BULLETIN K129
MODELS AFFECTED: MC-6, MC-10, MC-20
SUBJECT: Capillary Seal Replacement

BULLETIN K130
MODELS AFFECTED: All
SUBJECT: Use of Correct Type Rings in 2-Cycle Engines

BULLETIN K138
MODELS AFFECTED: All
SUBJECT: Elimination of Thrust Washers

BULLETIN K139
MODELS AFFECTED: All
SUBJECT: Breakage of Crankshaft Keyways

Figure 1.

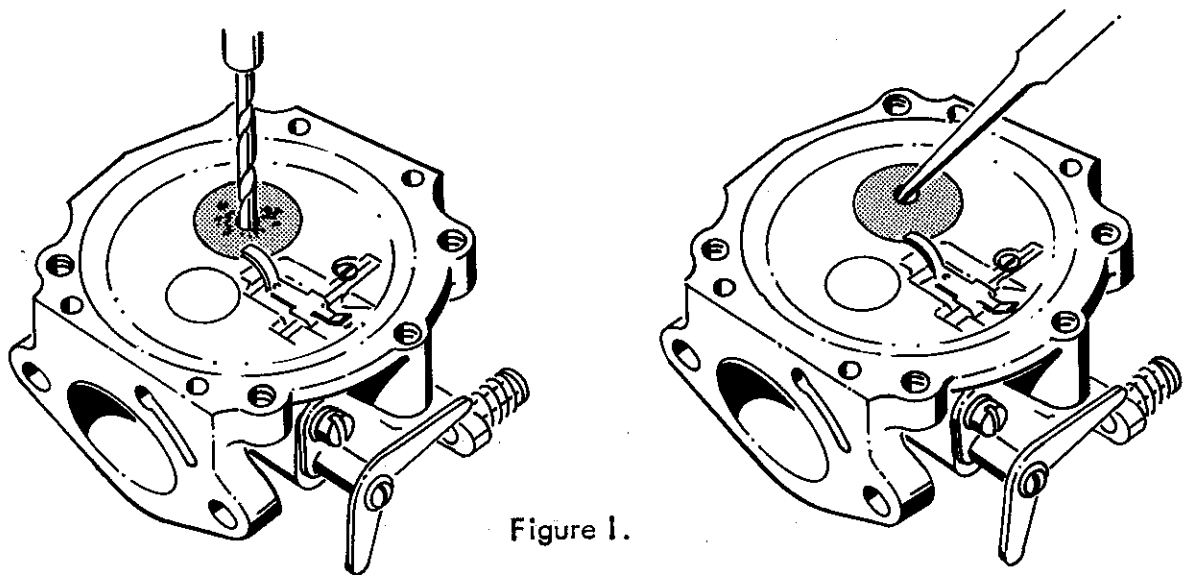
When the seal becomes plugged, the high speed mixture goes lean and the engine can be seriously damaged by the resulting lack of lubrication. The symptoms of a plugged screen are evident when continued backing out of the high speed needle does not enrich the mixture or correct the lean condition at high speeds.

Replacement of the capillary seal with a new seal will correct this condition. A new Expansion Plug, P/N 102758 will also be required.

1. Drill an 1/8-inch diameter hole in the center of the expansion plug (see figure 1).

2. Insert a sharp pointed tool, such as a punch or the handle end of a file into the hole and carefully pry out the expansion plug (see figure 1).
3. Using the sharp pointed tool, pry the plugged capillary seal out of its cavity.
4. Thoroughly clean the cavity with solvent to remove the oil film.
5. Press a new Capillary Seal, P/N 55690B, into the cavity until it bottoms.
6. Coat the edge of a new Expansion Plug, P/N 102758, with Pliobond cement or the equivalent, and place it on the shoulder of the cavity, convex side up. Tap the plug lightly with a small hammer to seat it. Then, to insure a tight fit, upset the plug with a 1/2-inch diameter pin punch and a heavier hammer.

FIGURE 1. 2-Cycle Ring.
Low outward pressure at ring ends.

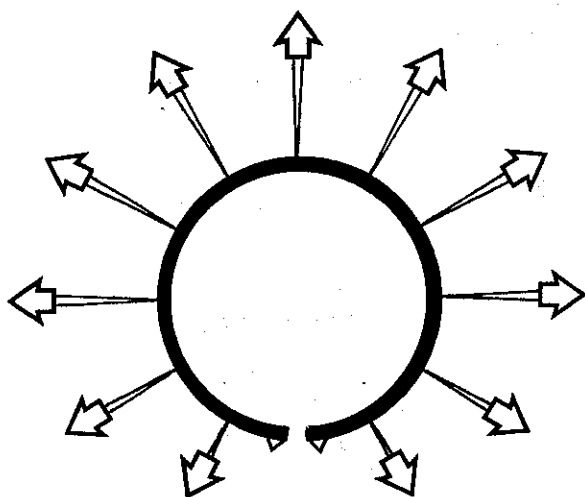
A 2-Cycle piston ring is designed to have low outward pressure at the ring points or ends (see figure 1).

This low outward pressure at the ring ends provides clearance for the port openings and prevents the rings from snagging in the ports.

FIGURE 2. 4-Cycle Ring.
The outward pressure is the same, including the ring ends, for full circumference of the ring.

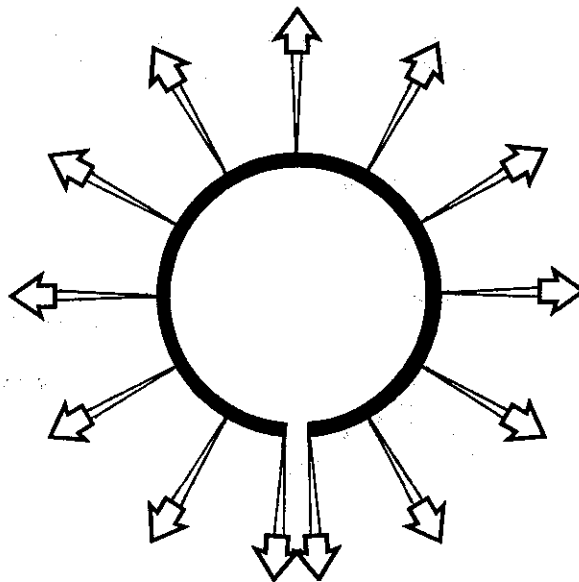
A ring designed for 4-Cycle operation will have the same outward pressure completely around the circumference of the ring, including the ring ends (see figure 2). When a 4-Cycle ring is used in a 2-Cycle engine, the outward pressure on the ring ends causes the ends to snag in the ports, breaking the ring.

When installing piston rings in a McCulloch kart engine, make sure the rings are designed for 2-Cycle operation. Installing rings designed for 4-Cycle operation will result in ring breakage and possible cylinder damage.

FIGURE 1

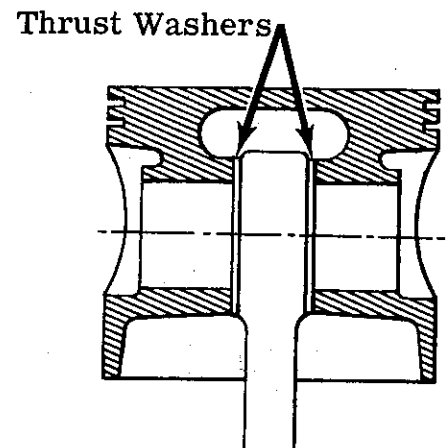
Current production engines (MC-8, -40, -70) do not use thrust washers on the piston pin between the connecting rod eye and piston pin bosses, as did earlier models (MC-1, -2, -5, -6, -7, -10, -20, -30) shown in figure 1. Eliminating thrust washers improves balance and reduces vibration.

FIGURE 2

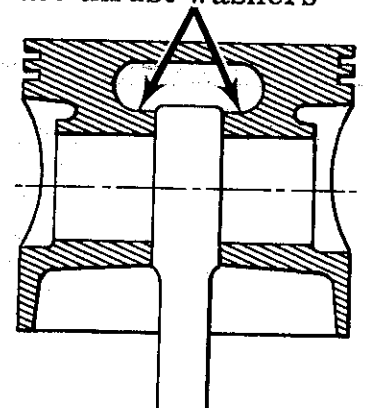
Elimination of thrust washers has resulted in new design pistons which have extended piston pin bosses (see figure 2). The bosses guide the connecting rod and limit its side motion to a minimum. Narrow boss pistons, as used on earlier models, are no longer available. Service replacement pistons are the new design. Since the inside edges of the piston pin bearings are installed flush with inner surfaces of the bosses, this changes piston pin length requirements.

It is extremely important that the correct piston pin be used when assembling new design piston and connecting rod. When the correct length piston pin is installed, the outer end of pin can be pressed in flush to 0.010 inch (0.254 mm) below outer edge of open end bearing without inner end of the pin touching the shield of the closed end bearing.

FIGURE 3

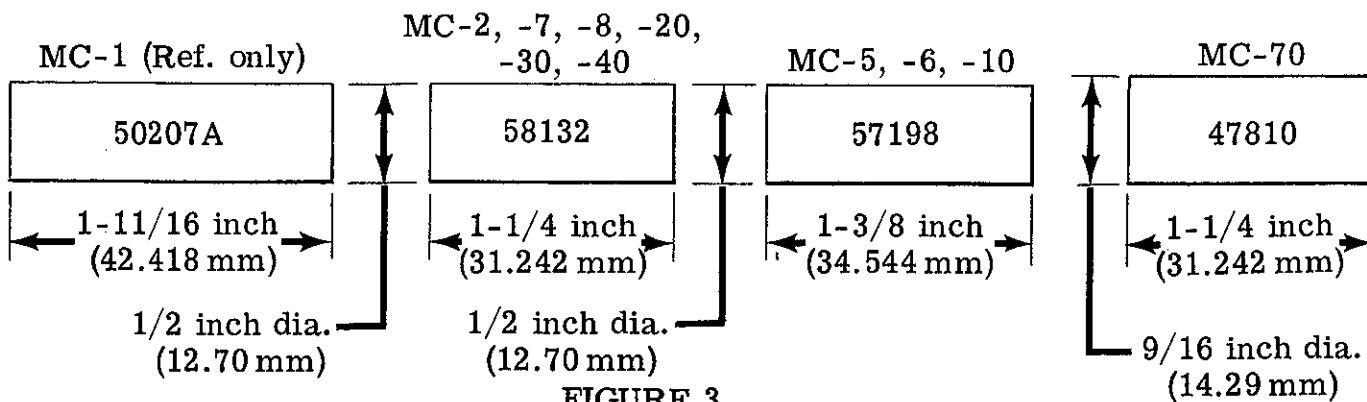
Two piston pins, having the same diameter but with different lengths, are available for service replacement in all models except MC-70, which uses a piston pin with a slightly larger diameter. Figure 3 shows each piston pin, its part number, length, diameter, and models where used.

FIGURE 4

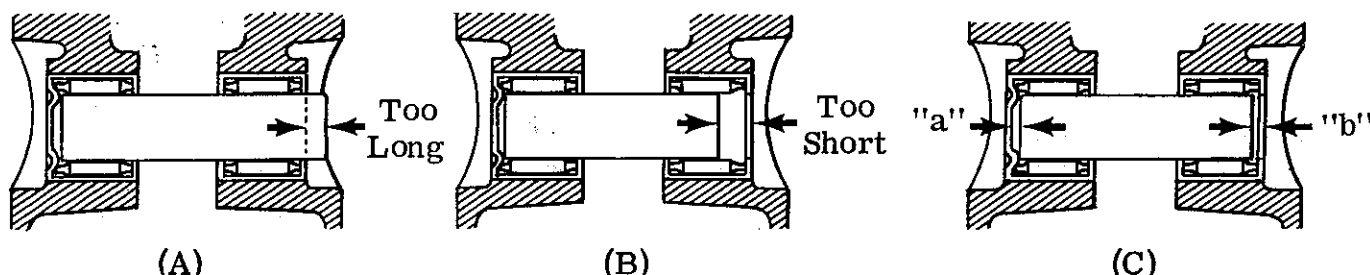
Before placing a pin in the piston, make sure that both piston bearings are installed with inner edges flush with the inner side of the pin bosses (figure 4).

FIGURE 6

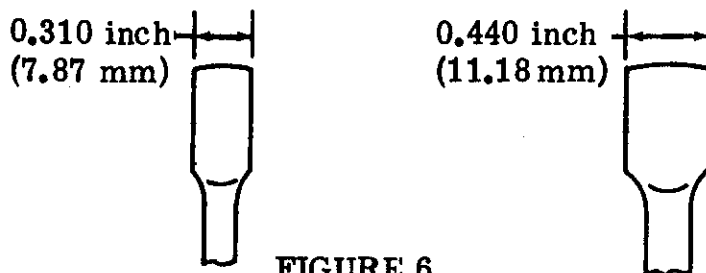
Connecting rods having different thicknesses at piston pin end are available for service replacement. These thicknesses are shown in figure 6.

To fit connecting rods to the piston, place the pin end of the rod between the piston pin bearings or bosses. Measure the clearance between the rod and bearings or bosses with a feeler gauge. If clearance is approximately 0.010 to 0.025 inch (0.25 to 0.64 mm), the rod is the correct one to use and can be installed without use of thrust washers. If clearance is approximately 0.085 to 0.095 inch (2.16 to 2.41 mm), two thrust washers, P/N 51209, should be installed with the connecting rod - one washer on each side of the rod. If clearance is more than 0.140 inch (3.56 mm), use a connecting rod which has a thicker end.

FIGURE 1

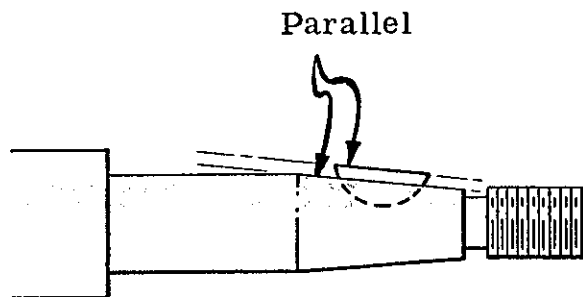
For most installations the Woodruff key should be installed in such a manner that it will bottom solidly in the keyway with its upper surface parallel with the shaft taper as shown in Figure 1.

The torque values for the retaining nut are 260 to 300 inch-pounds (22 to 25 foot-pounds).

FIGURE 2

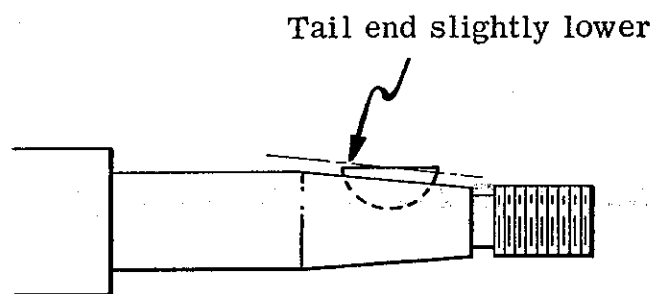
In other installations it may not be desirable to set the key parallel to the taper because the sprocket or clutch keyway is too shallow and will come in contact with the crankcase end of the Woodruff key.

When this occurs, the accessory (clutch or sprocket) will be lifted or cocked at this point and its taper will not fit the crankshaft taper. This will cause a false bottoming and incorrect torqueing for the retaining nut. As a result the nut will have a tendency to loosen during engine operation with the possibility of crankshaft keyway failure.

To eliminate this possibility, measure the minimum depth of the clutch or sprocket keyway and install the Woodruff key with its crankcase end slightly lower than this dimension as shown in Figure 2.
